**Design Addendum**

For Reselton Properties

This Design Addendum has been prepared in direct response to a series of comments provided by London Borough of Richmond Upon Thames regarding the submitted proposals for the former Stag Brewery site in Mortlake.

Submitted proposed alterations to existing south elevation

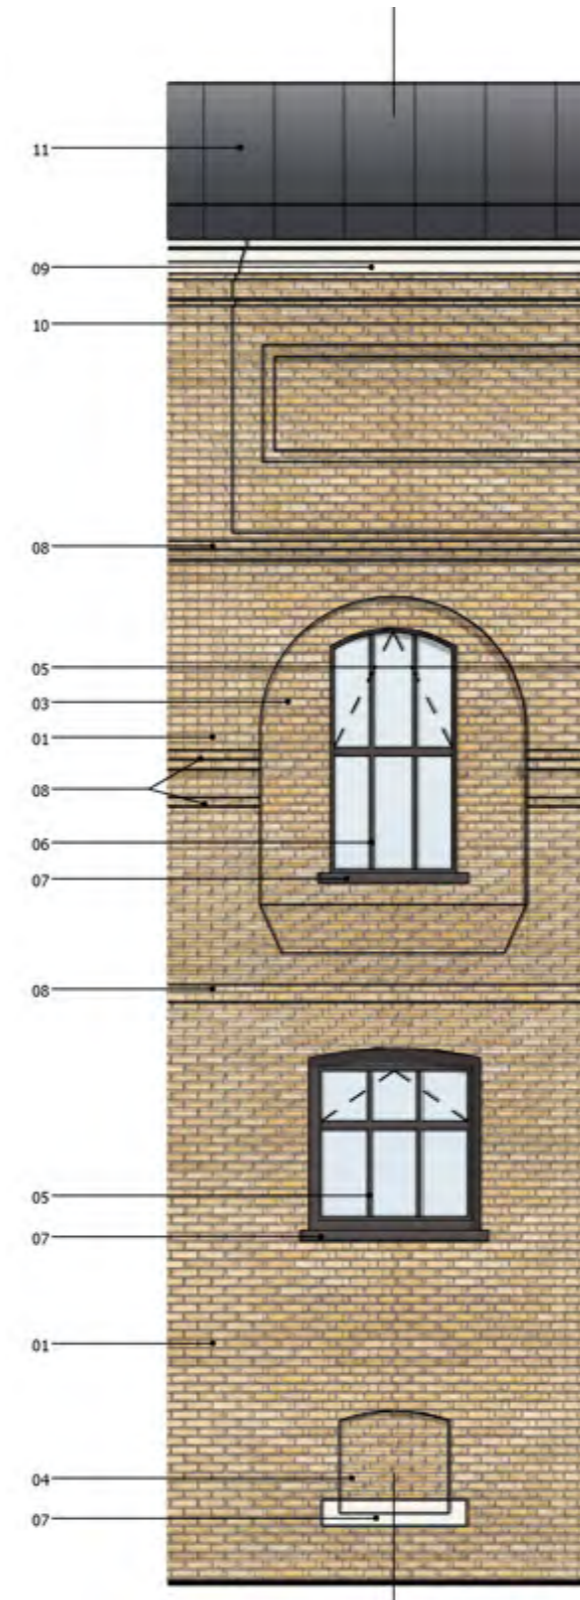
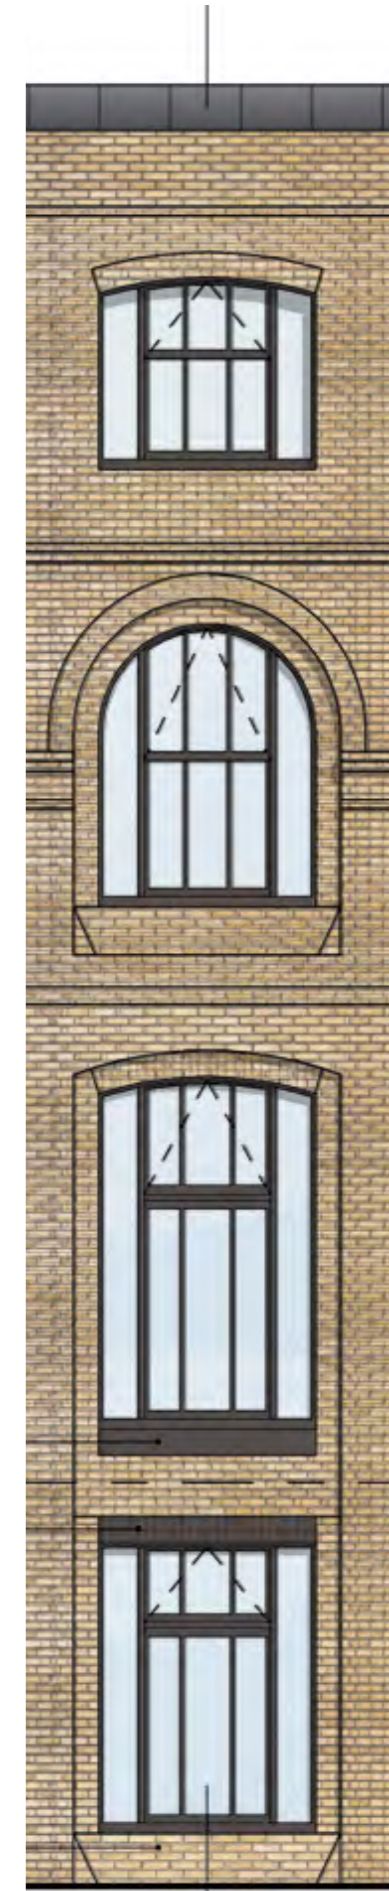
2. Front/ south elevation: Was the fenestration inserted on the High Street elevation based on historical information? It is not clear as to whether fenestration designs are copies of originals; this needs confirmation. Provide details of fenestration choice.

The fenestration designs for the proposed altered south elevation are copies of the existing timber casement windows. It is proposed that all new windows will be double glazed timber casement windows.

The fenestration in the new areas of façade to the north (facing the new 'High Street/ Thames Street') and east are proposed as contemporary interpretations (as opposed to direct copies) of the existing arched window openings on the retained south elevation.

The diameter of the existing arched openings has been utilised to form the outermost opening of the new second floor level window reveals. That shape has been offset in stepping brick reveals.

A hierarchy is also proposed to these window openings, with the re-interpreted arch positioned at second floor level (same level as on the retained façade) and a paired set of windows with a stepped flattened arch reveal below and a squatter flattened arch window at the top of the building.
